**Response to Comments
on
EPA Draft 2020 Permit Modification to the 2016 Reissued RCRA Permit and
Associated Statement of Basis for EPA’s Remedial Action for the “Rest of River”
Portion of the Housatonic River**

GE-Pittsfield/Housatonic River Site

December 2020

U.S. Environmental Protection Agency
Region 1 (EPA New England)

**FIGURE 2
SURFACE WATER PROTECTION ZONE A,
LEE PUBLIC WATER SUPPLY**

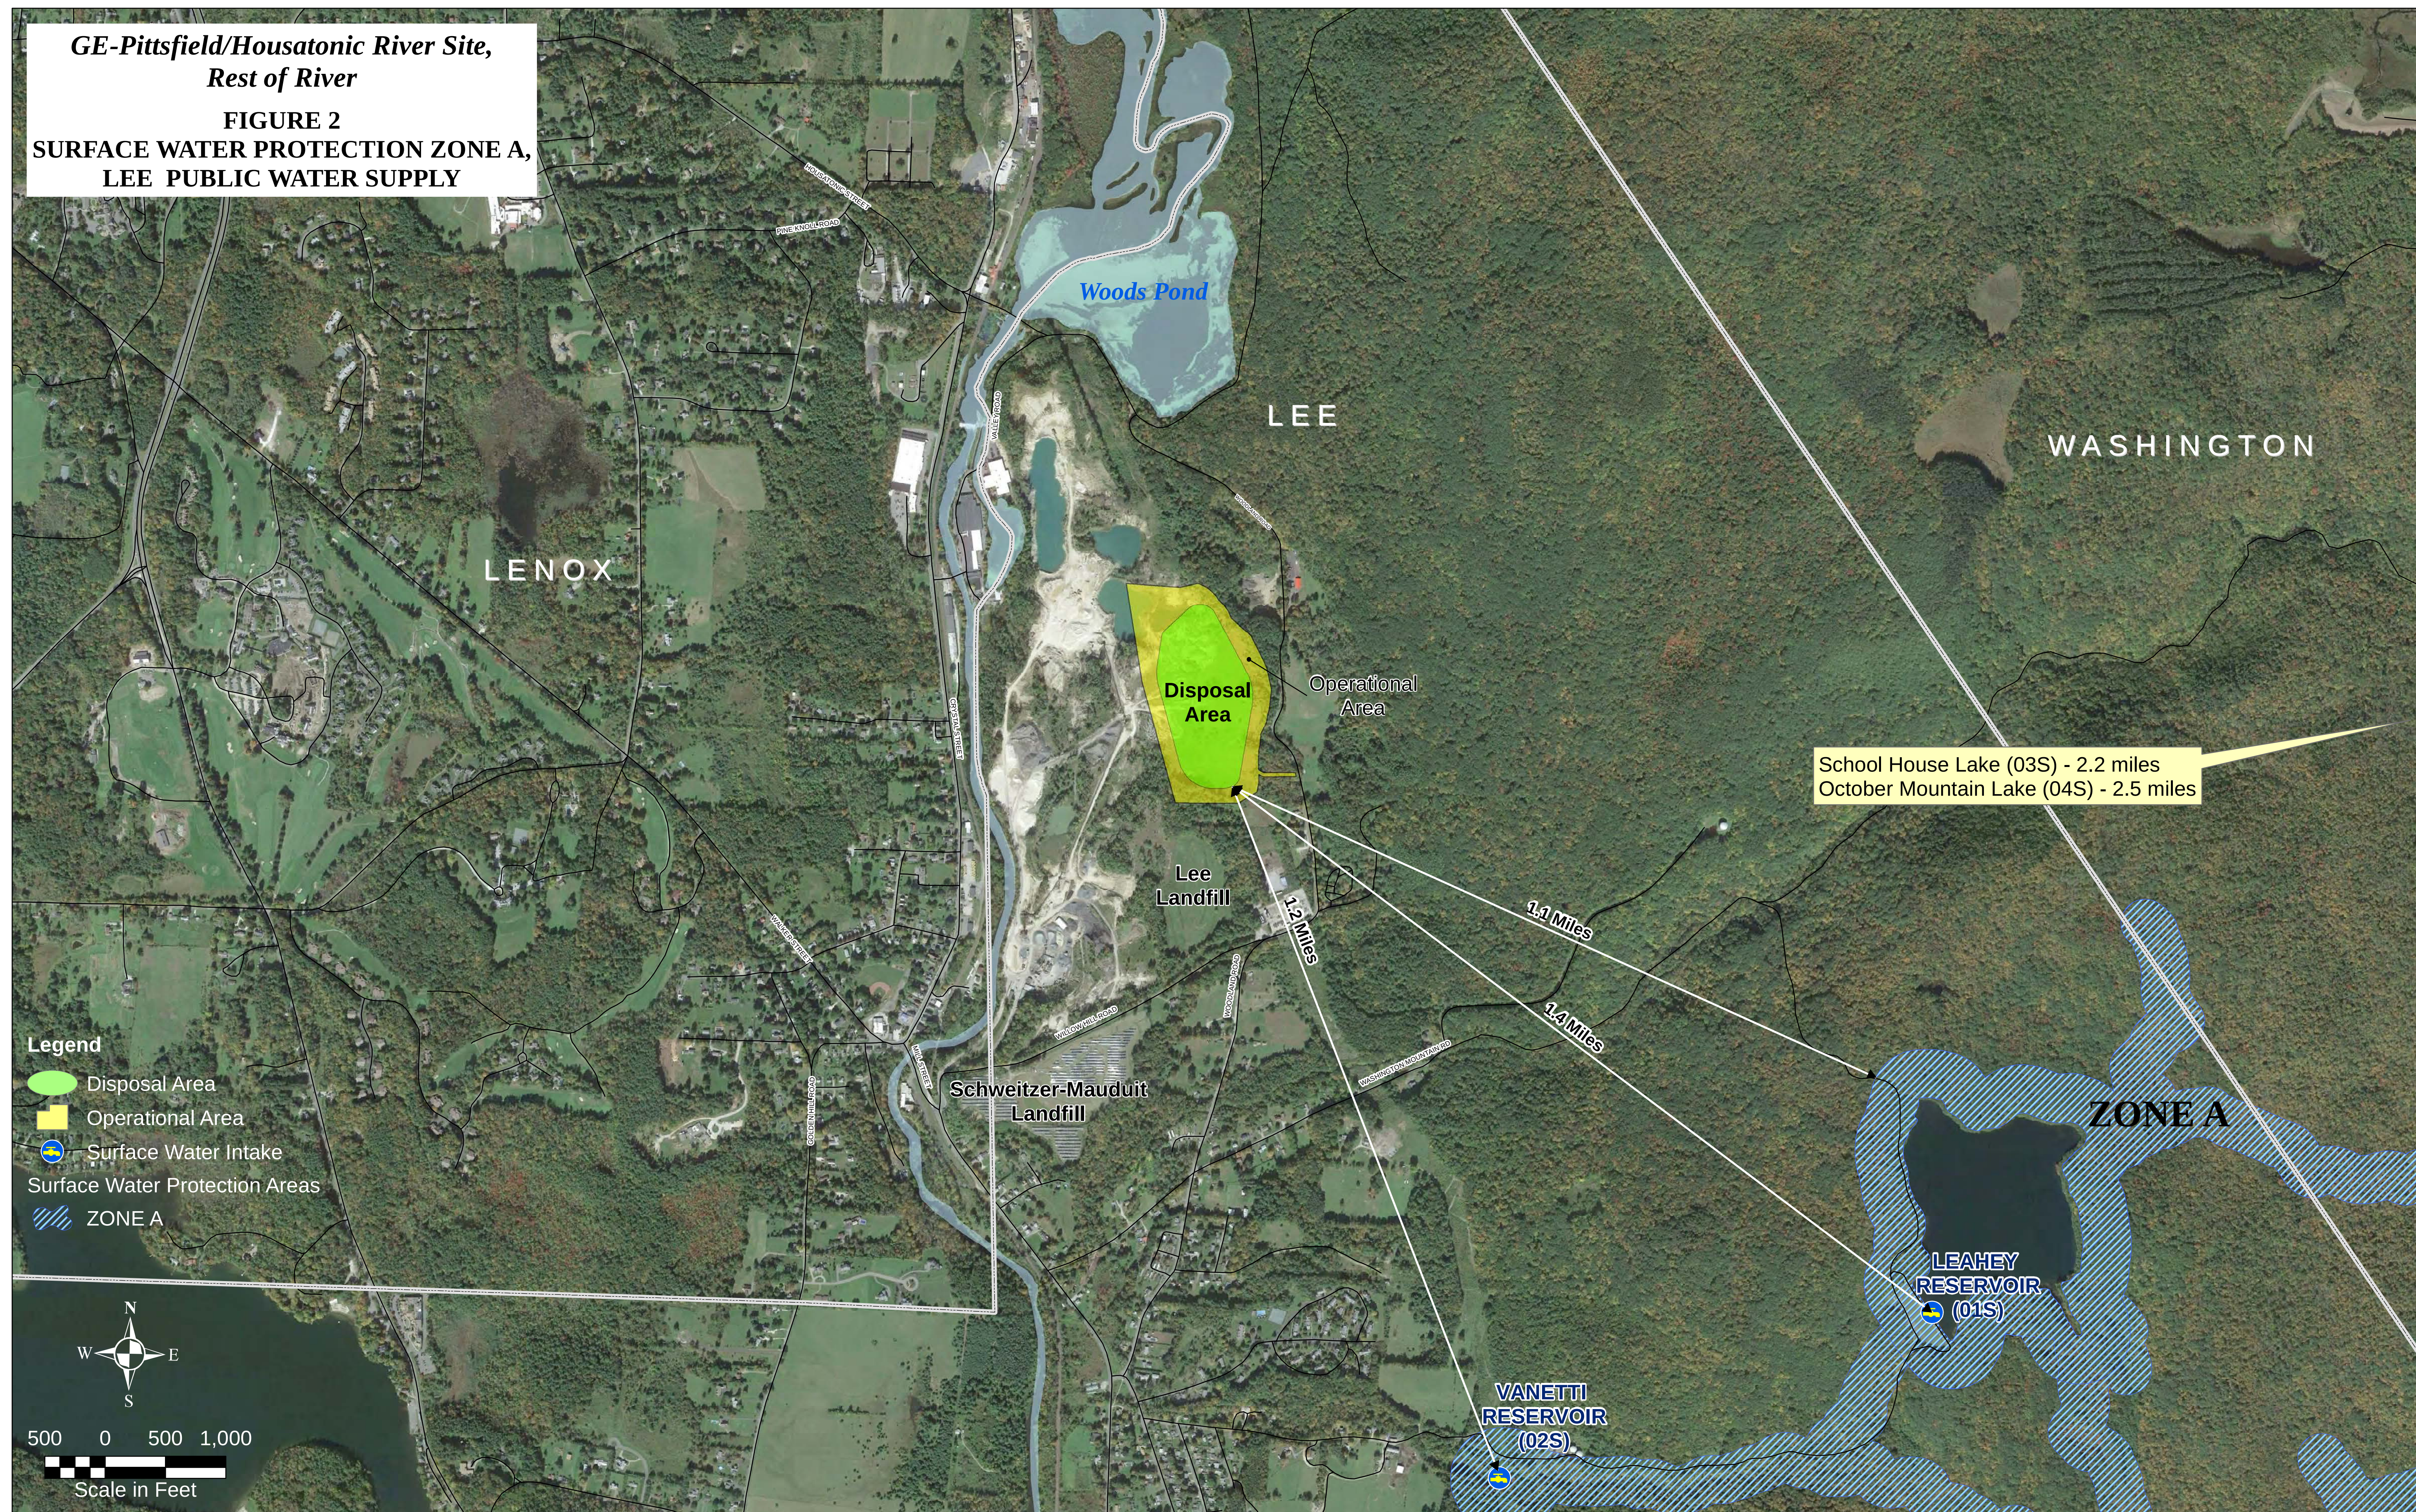
Comment II.A.1: Several commenters expressed strong opposition to the proposed UDF location. Specific comments in this category cited the consistent vehement community opposition to local disposal; air emissions and risks to the community during and after construction; concerns about frost effects, seismic activities/earthquakes, or extreme weather events on the UDF; the suitability of soils at the location for a landfill and contamination of groundwater; and the potential for re-contamination of the River from a failure or leaking of the landfill.

Regarding questions relative to the suitability of soils underlying the UDF location, it is first important to note that two other landfills already exist in this immediate area. Figures 1 and 2. Neither of those existing landfills have the benefit of a bottom liner, whereas the UDF will have a double bottom liner and leachate collection system. The UDF’s liner system is protection against concerns regarding permeability of the underlying soils. For TSCA Chemical Waste Landfills, the regulations prescribe that a bottom liner be placed where underlying soils are permeable. 40 C.F.R. 761.75. The UDF will meet this requirement. Furthermore, state solid waste landfill regulations would allow the bottom of the landfill to be constructed to within 4 feet of the water table (310 CMR 16.40.3(a)(12)), whereas the Permit increases this buffer to no less than 15 feet. The underlying soil characteristics at this location have the added advantage of allowing the preparation of an ideal sub-base for proper grading, placement, and construction of the bottom double liner system. Permit, II.B.5.

FIGURE 4
ALLENDALE SCHOOL PCB
AIR SAMPLING RESULTS

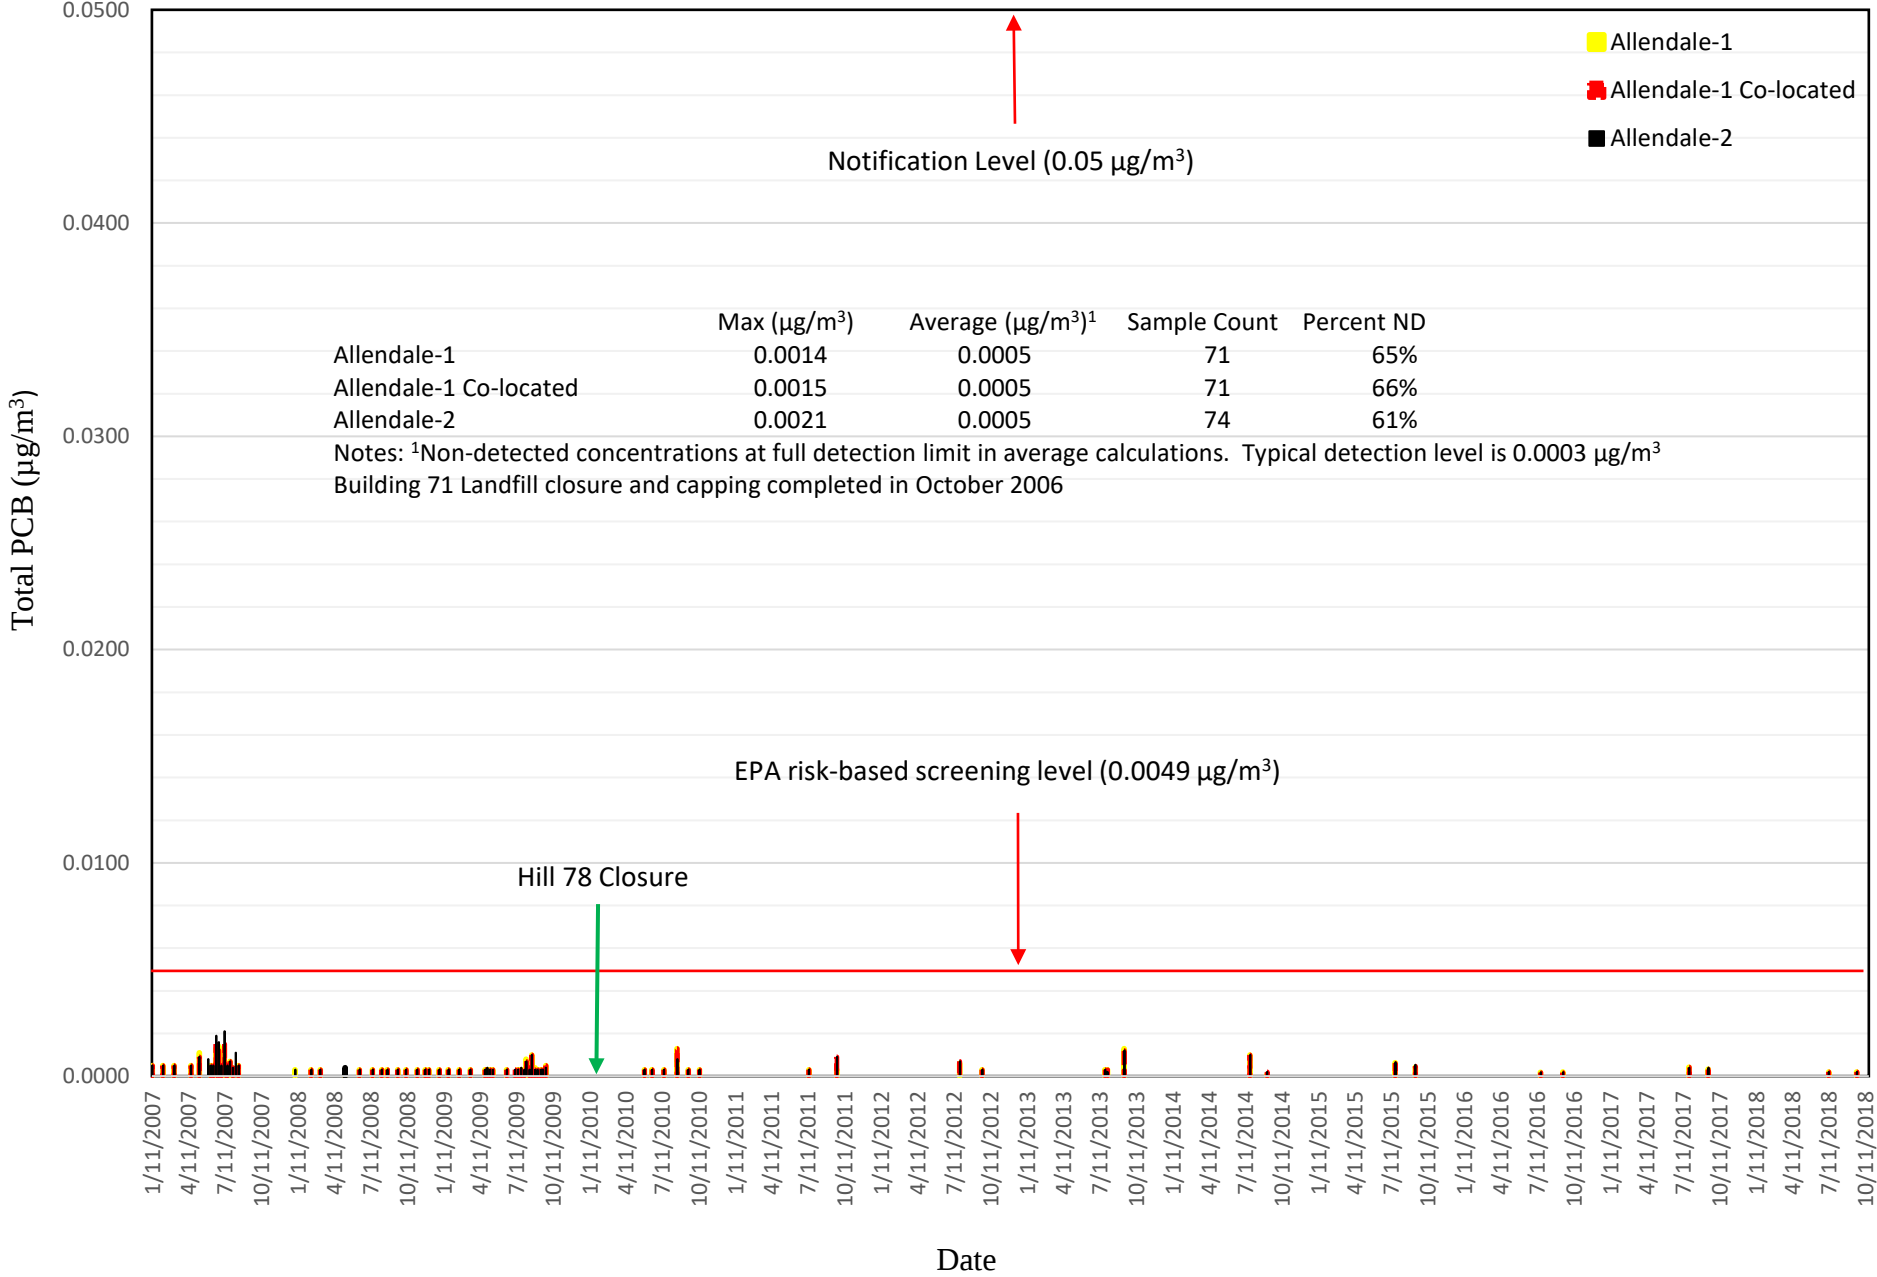
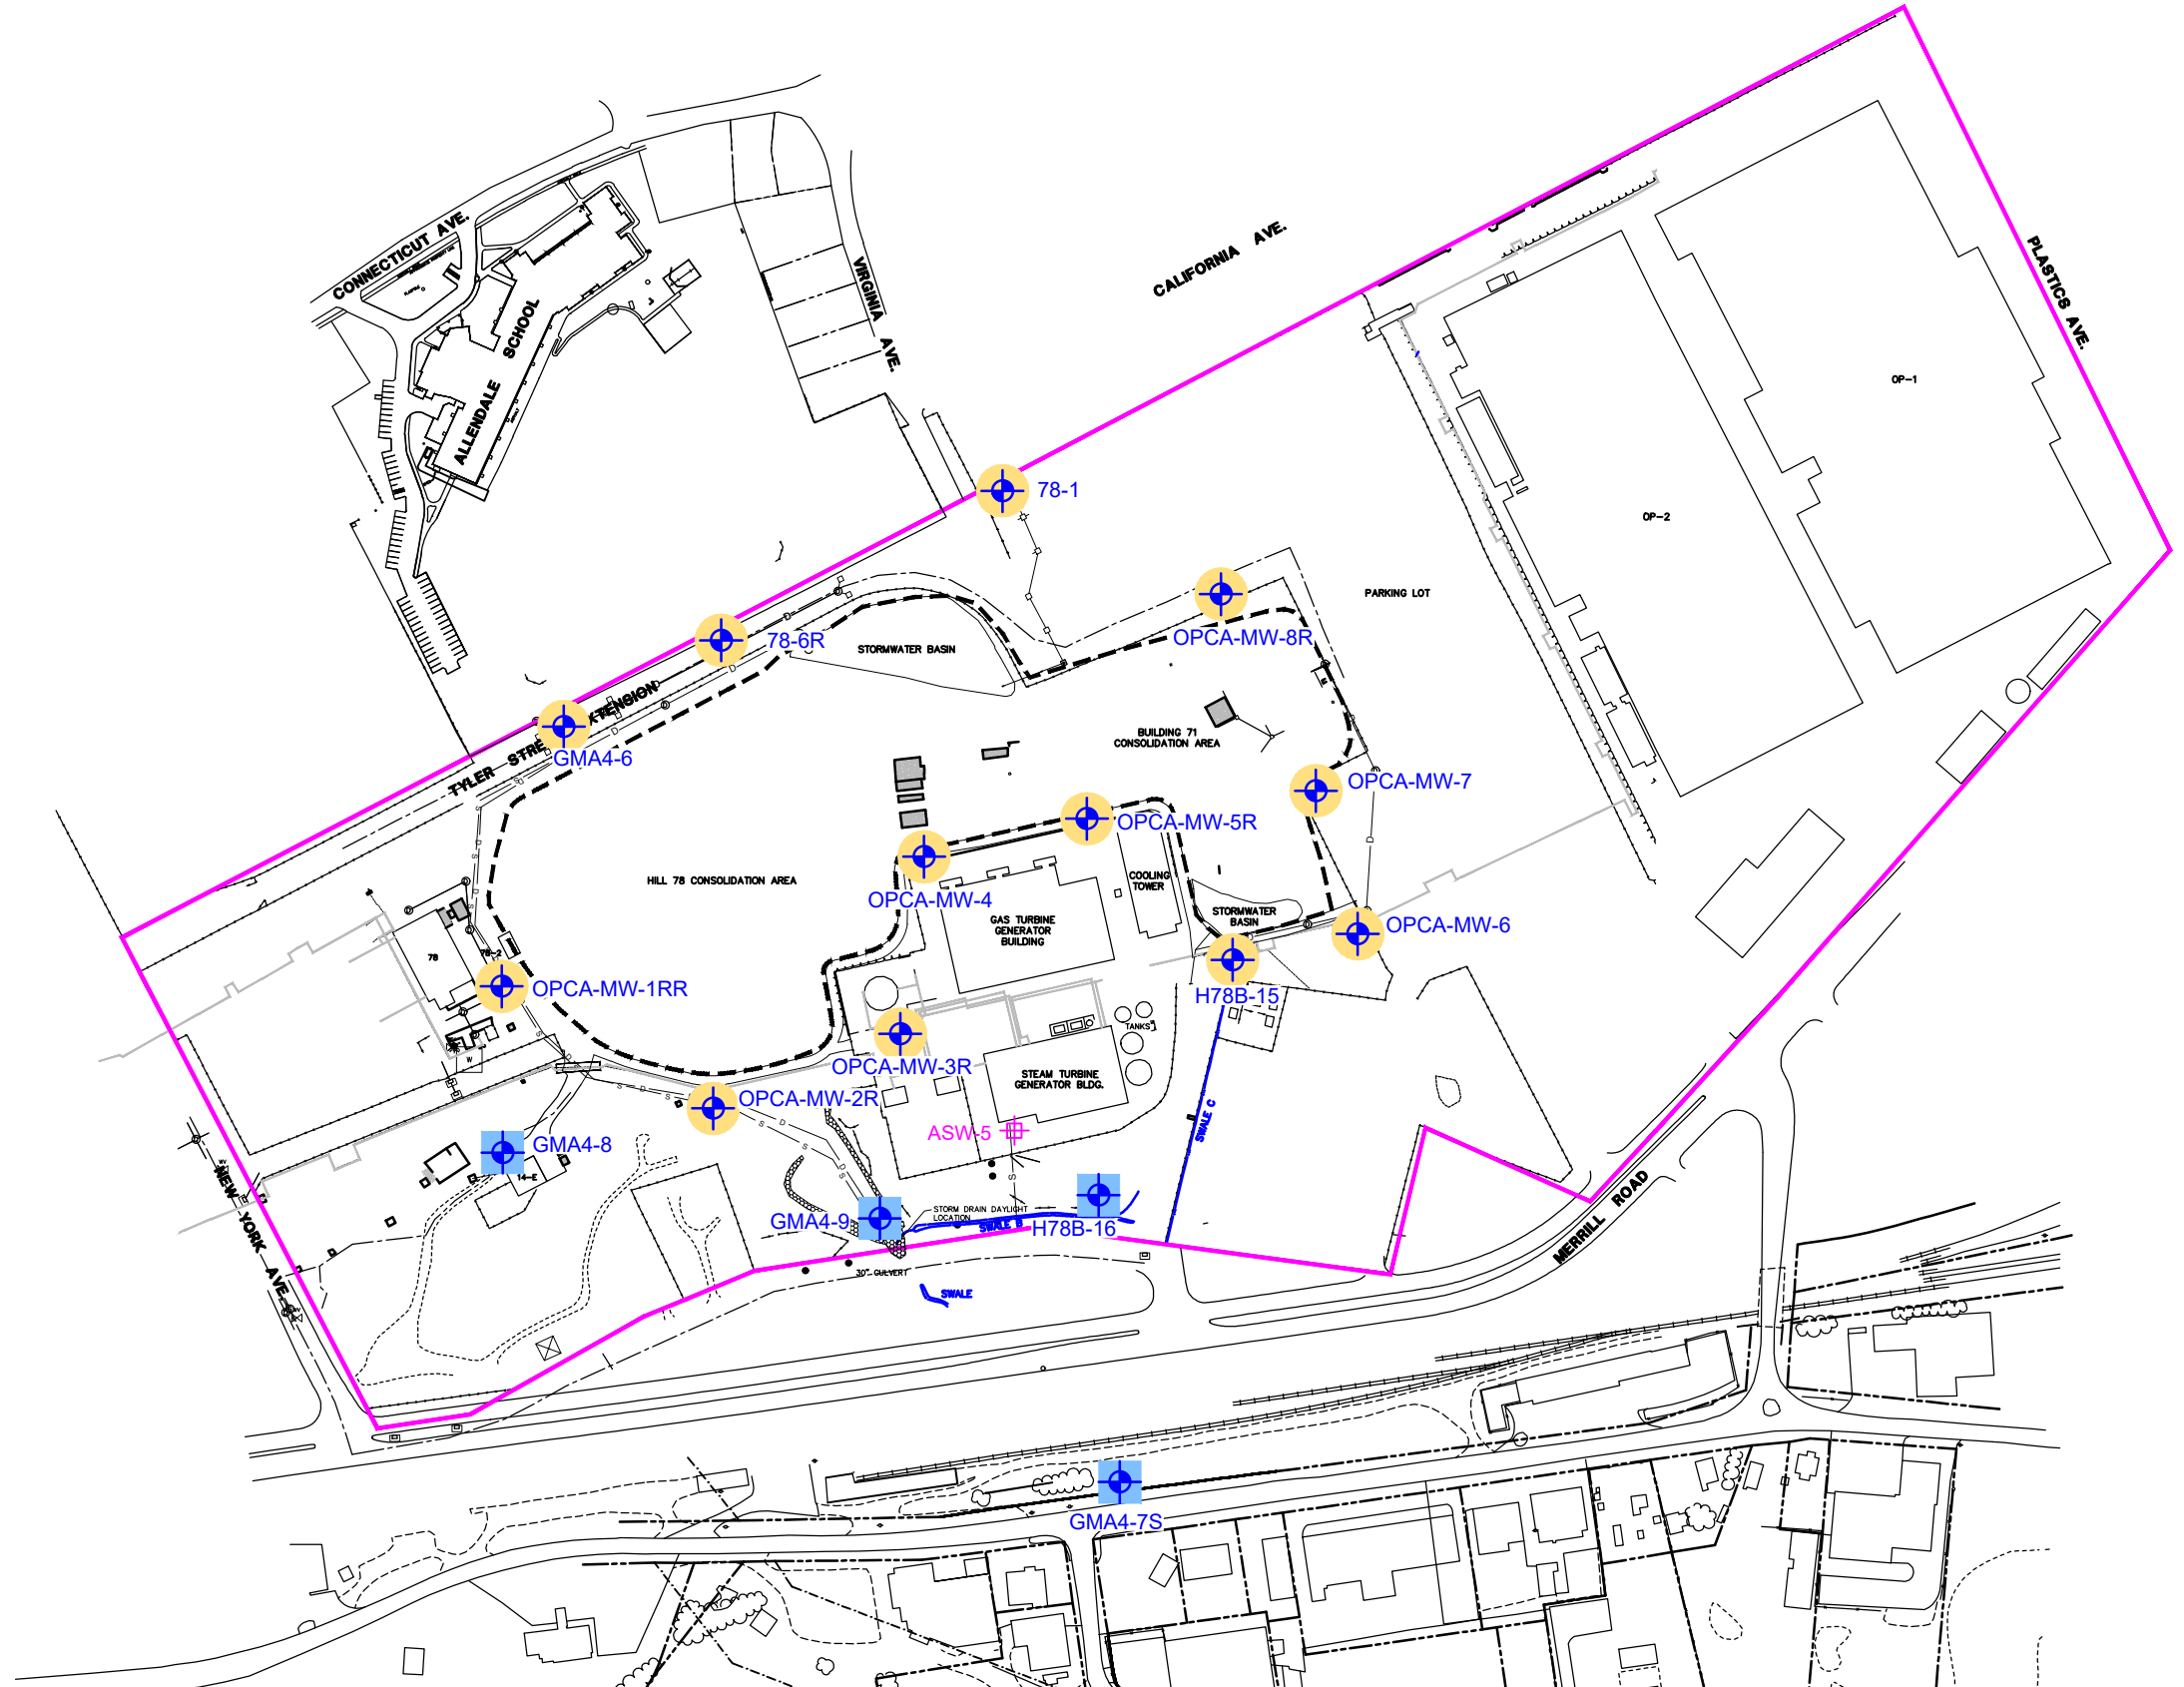
At the onset of consolidation activities in 1999, EPA required that GE monitor the air surrounding the OPCAs at five air monitoring stations. Figure 3 presents the current OPCA air monitoring locations. These locations are on GE property and are all within a maximum of 250 feet of the OPCA disposal areas. In 1999, the Region set a site-specific notification level of a 24-hour average of 0.05 micrograms (μg) PCBs per cubic meter of air ($\mu\text{g}/\text{m}^3$) and an action level of $0.100 \mu\text{g}/\text{m}^3$. If a notification level was exceeded, GE was required to notify EPA as soon as practicable, but no later than 24 hours after receipt of the data showing such an

From 2007 through 2018, the average PCB air concentration was 100 times below the site-specific notification/action level and approximately 10 times below EPA’s national screening level. Figure 4. The data from 2019 and 2020 are, on average, lower than the $0.0005 \mu\text{g}/\text{m}^3$ average concentration from 2007 through 2018. Tables 1 and 2.
